# CAFO FACILITY INSPECTION REPORT

<u>8335630001</u> WDID NUMBER	<u>Andy Dyt</u> OWNER NAME	<u>Dyt Dairy No. 1</u> FACILITY NAME
<u>CAG018001</u> NPDES NUMBER	<b>Ex. 6 Personal Privacy (PP)</b>	
<u>R8-2007-0001</u> RWQCB ORDER NO.	<u>Corona, CA 91720</u> OWNER CITY AND STATE	<u>Corona, CA 91720</u> FACILITY CITY AND STATE
<u>04/09/2013</u> SCHEDULED INSPECTION DATE	<u>Andy Dyt</u> OWNER CONTACT	<u>Andy Dyt</u> FACILITY CONTACT
<u>04/09/2013</u> ACTUAL INSPECTION DATE	<b>Ex. 6 Personal Privacy (PP)</b>	
<u>Cucamonga Channel</u> RECEIVING WATER	<u>Ex. 6 Personal Privacy (PP)</u>	
	FACILITY LATITUDE	FACILITY LONGITUDE

On April 9, 2013, a Concentrated Animal Feeding Operation (CAFO) inspection was conducted for Santa Ana Water Board Order No. R8-2007-0001 - 'General Waste Discharge Requirements for Concentrated Animal Feeding Operations (Dairies and Related Facilities) within the Santa Ana Region', NPDES General Permit No. (CAG018001) at Dyt Dairy No. 1 in Corona, California (refer to Photo 1). The inspector provided a phone call and left a voicemail for Mr. Andy Dyt (Owner, Dyt Dairy No. 1) at approximately 2:00 PM on April 9, 2013. At the conclusion of the inspection, the inspector

**Photograph 5.** View facing west of basin No. 3 located in the central-west portion of the Facility. Note this basin collects excess process wastewater and storm water runoff from field No. 1. Also note basin No. 3 did not contain a depth marker.

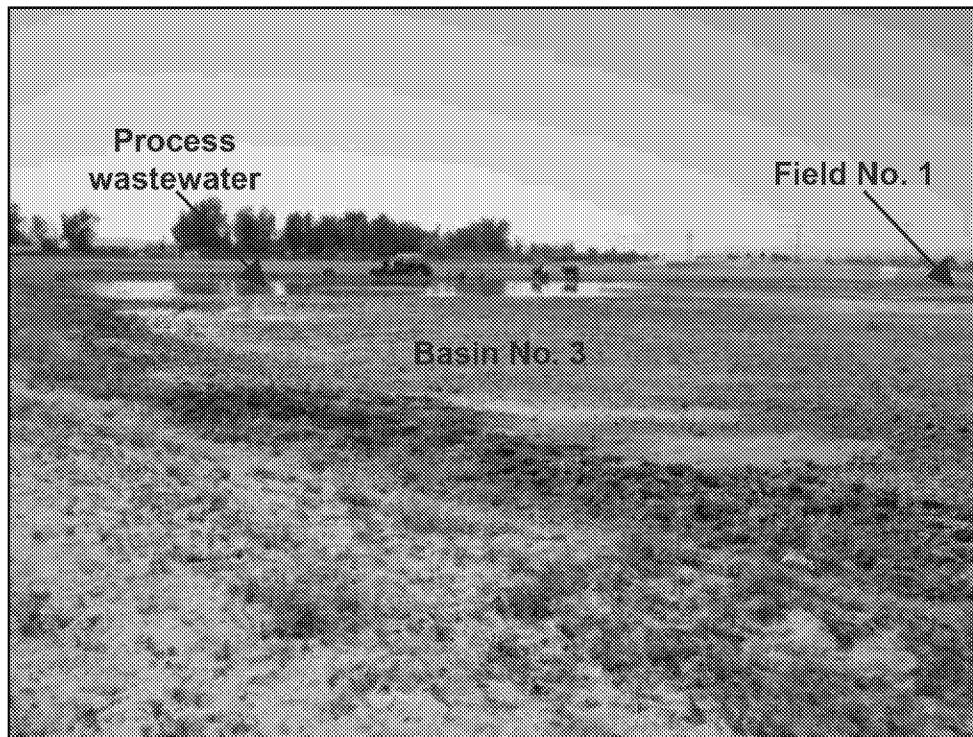
1. Depth markers were not installed in basin Nos. 1 and 3 as required by Permit Attachment B - Monitoring and Reporting Program, Section I.B.1 (refer to Photos 5 and 9).

1. The inspector observed, during the inspection, that depth markers had not been not installed in basin Nos. 1 and 3 located in the western portion of the Facility as required by the Permit (refer to Photos 5 and 9). Mr. Dyt stated that the Santa Ana Water Board had previously given him approval to only install and maintain a depth marker in basin No. 2. It should be noted that basin No. 1 contained the Facility emergency concrete spillway; however, did not contain a depth marker (refer to Photos 9 through 12). Permit Attachment B - Monitoring and Reporting Program, Section I.B.1 states that "a marker shall be placed within each pond or impoundment to indicate the minimum capacity necessary to contain the runoff and direct precipitation of the 25-year, 24-hour rainfall event."

**Photograph 6.** View facing west of basin No. 2 located along the southern perimeter in the western portion of the Facility. Note the basin receives storm water runoff from central and southern corrals. Also note the depth marker did not contain depth markings to estimate freeboard.

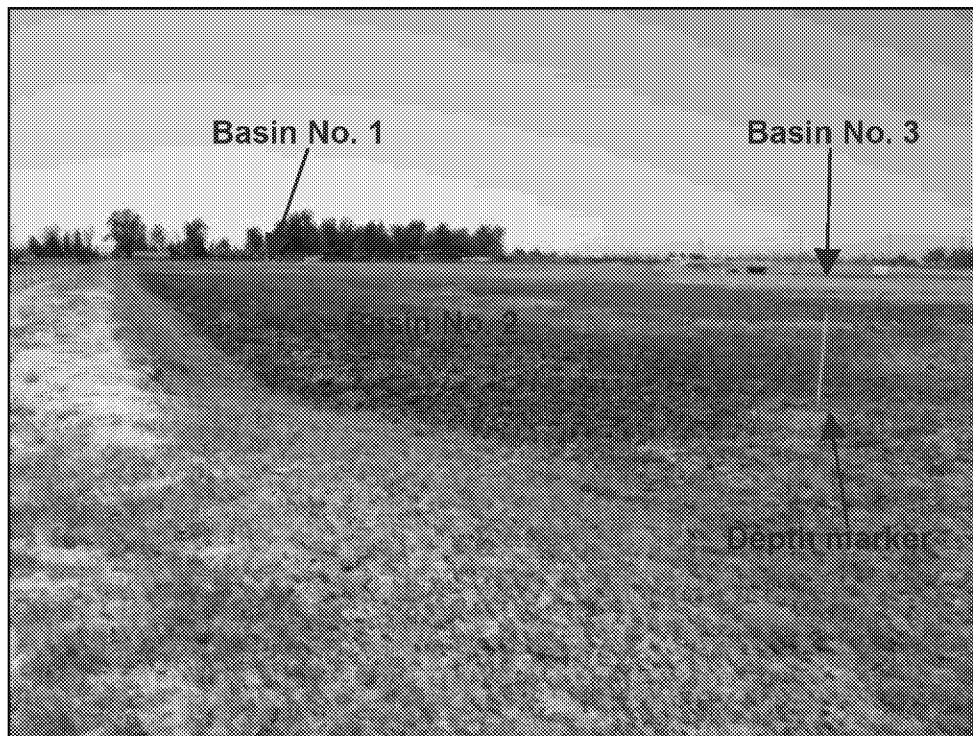
2. The inspector observed, during the inspection, that the depth marker installed in basin No. 2 did not have depth measurement markings to clearly identify basin depth and an estimate of freeboard (refer to Photos 6, 7, and 8). Permit Attachment B - Monitoring and Reporting Program, Section I.B.1 states that "a marker shall be placed within each pond or impoundment to indicate the minimum capacity necessary to contain the runoff and direct precipitation of the 25-year, 24-hour rainfall event."

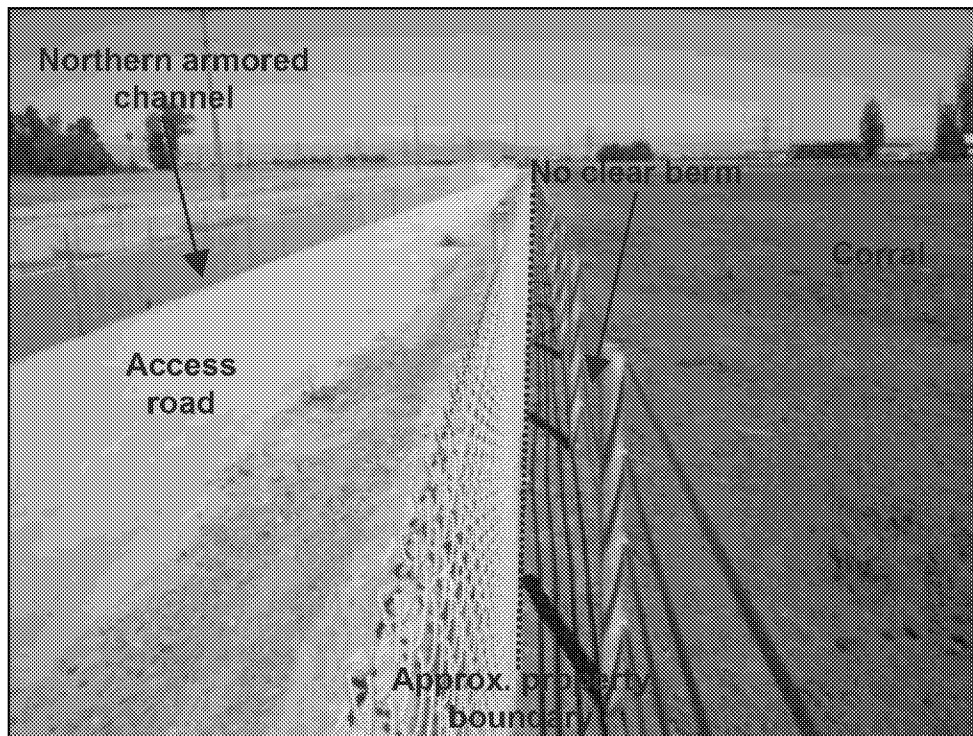
4. A release of manure offsite to a flood control access road was observed along the northern Facility perimeter (refer to Photos 14 and 15). In addition, a berm had not been constructed along the northern Facility perimeter in accordance with the EWMP Site Plan. Discharge Prohibition IV.B of the Permit states that a "disposal of manure to land is prohibited."

1. The EWMP was not fully implemented onsite at the Facility as required by the Permit. Construction Note No. 2 of the EWMP Site Plan identifies that a berm will be constructed along the northern perimeter of the Facility, adjacent to the northern armored flood control channel, in accordance with Section "B"- "B" of the EWMP Site Plan. The inspector observed, during the inspection, that an earthen berm along the northern portion of the northern corrals was not constructed per the EWMP Site Plan Section "B"- "B" (refer to Photos 14 and 15). As a result, the Discharger was not fully implementing the approved EWMP. Provision VII.C.3.b of the Permit states that "the discharger shall develop and fully implement an Engineered Waste Management Plan (EWMP) acceptable to the Executive Officer." The Discharger shall fully implement the EWMP as required by Provision VII.C.3.b of the Permit.

1. The inspector observed, during the inspection, evidence of a previous release of manure offsite to the north from the northwestern cow corral onto an offsite armored flood control channel access road (refer to Photos 14 and 15). Construction Note No. 2 of the EWMP Site Plan identifies that a berm shall be constructed per Section "B"- "B" along the northern perimeter of the Facility, adjacent to an offsite armored flood control channel. A berm was not installed along the northern perimeter of the northern corrals, resulting in a release of manure offsite onto the armored flood control channel access road which subsequently flows to Cucamonga Channel. As a result, manure was released offsite to the north. Discharge Prohibition IV.B of the Permit states that a "disposal of manure to land is prohibited."
